Project	IEEE 802.16 Broadband Wireless Access Working Group <http://ieee802.org/16>	
Title	PKMv2 Security Framework Corrections	
Date Submitted	2005-01-24	
Source(s)	Yigal Eliaspur, Avishay Shragna, Sanjay Bakshi, David Ayoun Intel Corporation	yigal.eliaspur@intel.com Voice +972-54-7884877 sanjay.bakshi@intel.com avishay.shraga@intel.com david.ayoun@intel.com
Re:	IEEE P802.16e/D5a	
Abstract	There are still areas in the PKMv2 security framework that requires major corrections This contribution proposed a resolution for those major issues.	
Purpose	Adoption of proposed changes into P802.16e /D5a-2004	
Notice	This document has been prepared to assist IEEE 802.16. It is offered as a basis for discussion and is not binding on the contributing individual(s) or organization(s). The material in this document is subject to change in form and content after further study. The contributor(s) reserve(s) the right to add, amend or withdraw material contained herein.

PKMv2 Security Framework Corrections

Figure 1

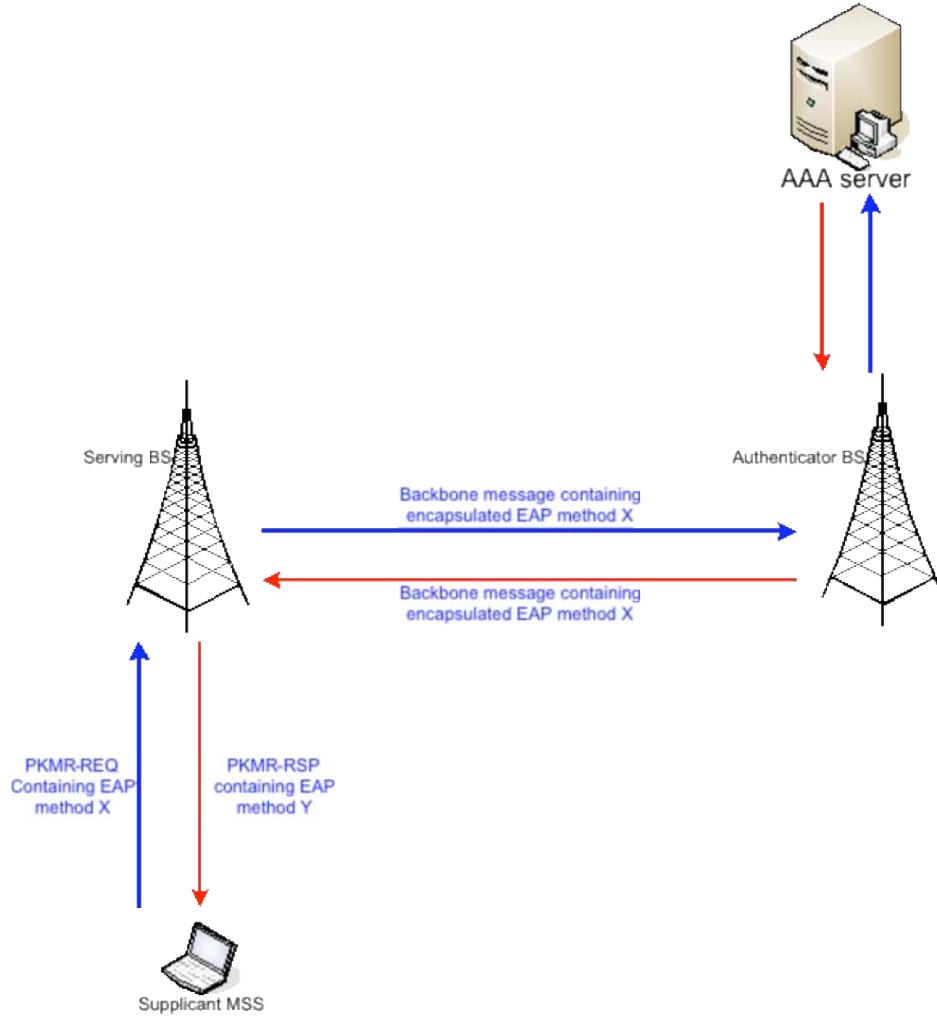
Two MAC management messages are added: PKMR-REQ and PKMR-RSP for Privacy Key Management Remote. These messages are similar to PKM-REQ and PKM-RSP respectively but the serving BS when receiving them will only verify the signature (OMAC or HMAC) and, if valid, forward the message to the target BS.

The general model is illustrated in figure 1.

A new type is added to both the PKM-REQ and PKMR-REQ for the MSS to start the EAP authentication

Figure xx1: AK with RSA only authorization process

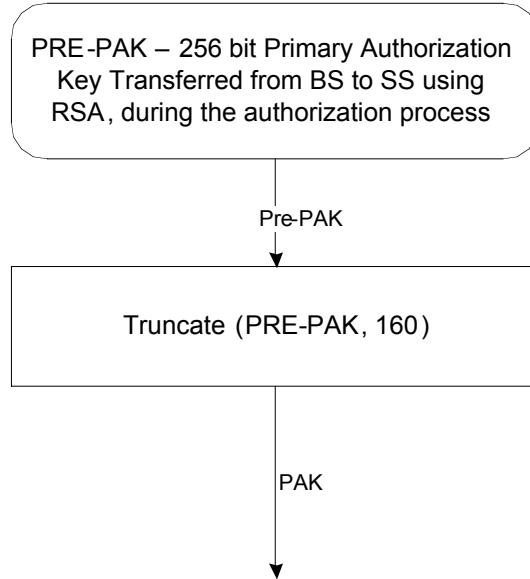
Figure xx1 outlines the process to calculate the AK when the authorization process has taken place, but where the EAP based authentication process hasn't taken place, or the EAP method used has not yielded an AAA-key:

Figure xx2: AK with RSA+EAP authorization process

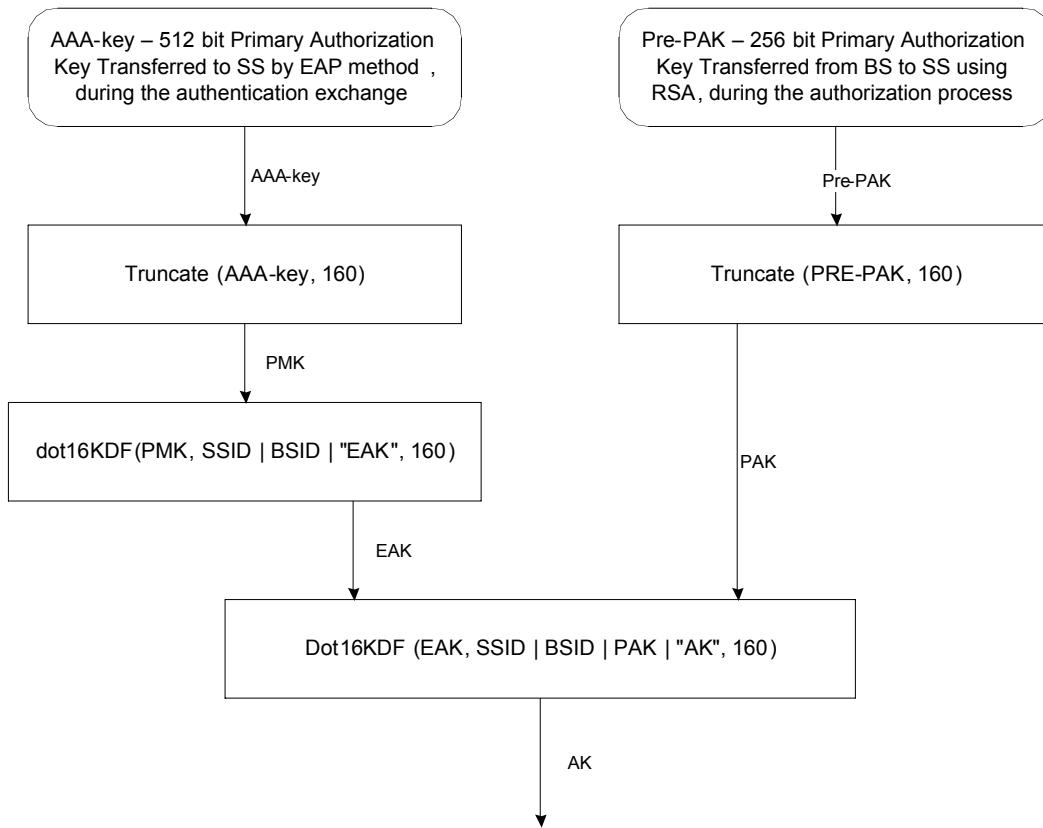
Figure xx2 outlines the process to calculate the AK when both the authorization exchange has taken place, yielding a PAK and the EAP based authentication exchange has taken place, yielding an AAA-key:

Figure xx3: AK with EAP only authentication

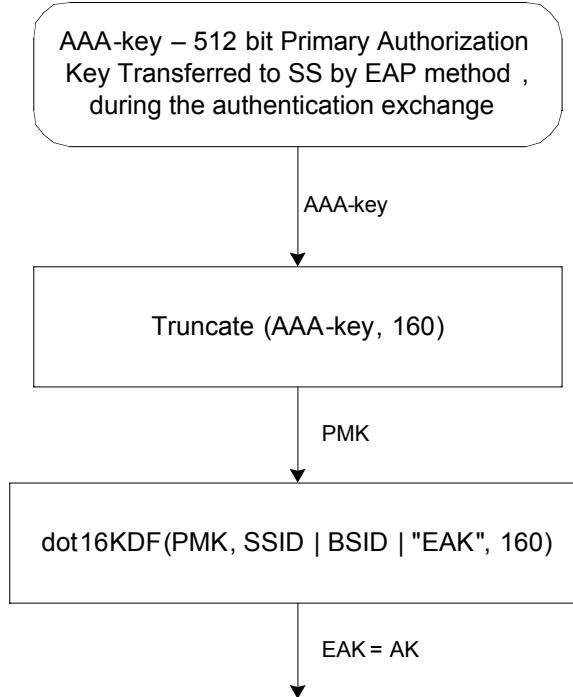
Figure xx3 outlines the process to calculate the AK when only the EAP based authentication exchange has taken place, yielding an AAA-key:

Figure xx4: AK key derivation from AK

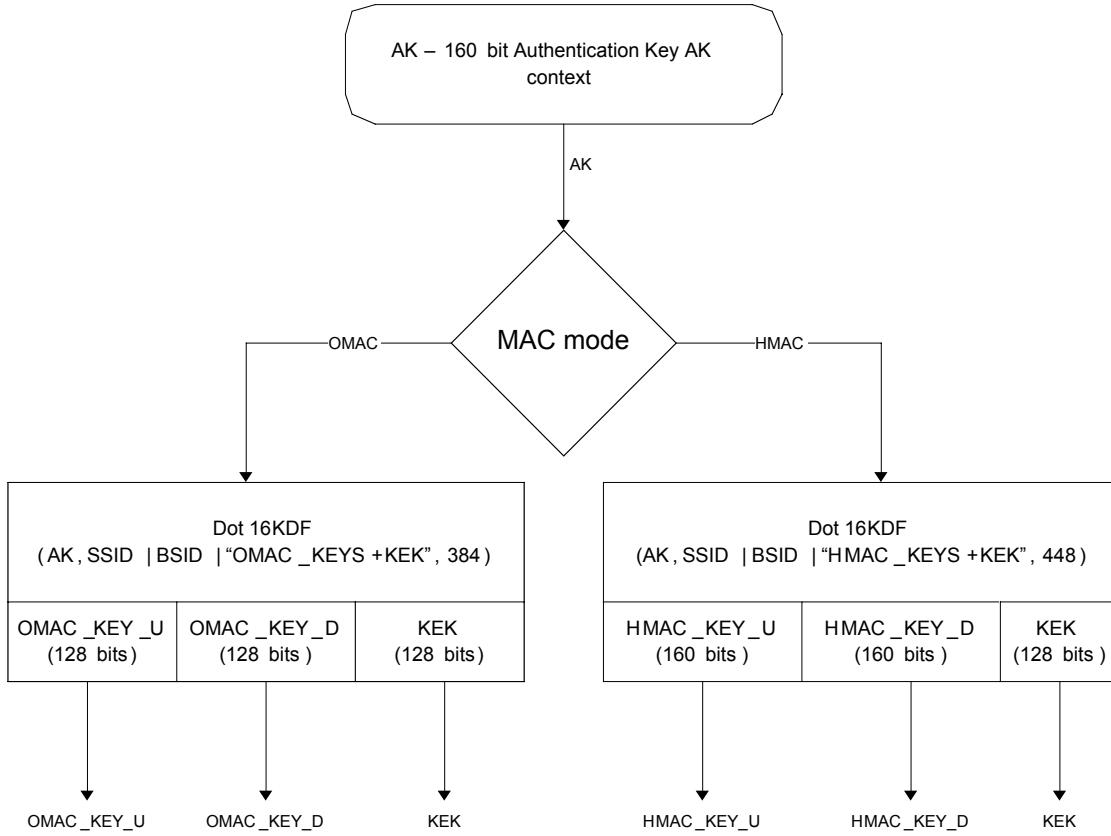
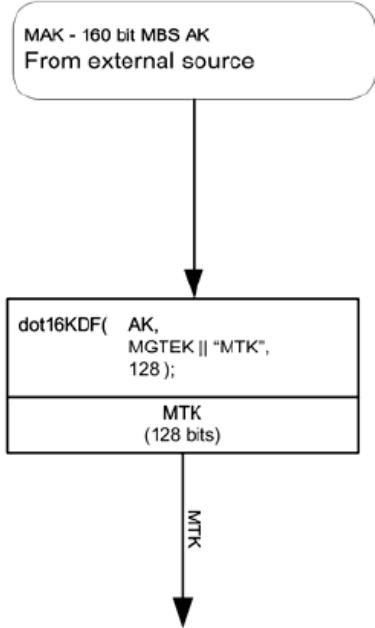
Figure xx4 outlines the unicast key hierarchy starting from the AK:
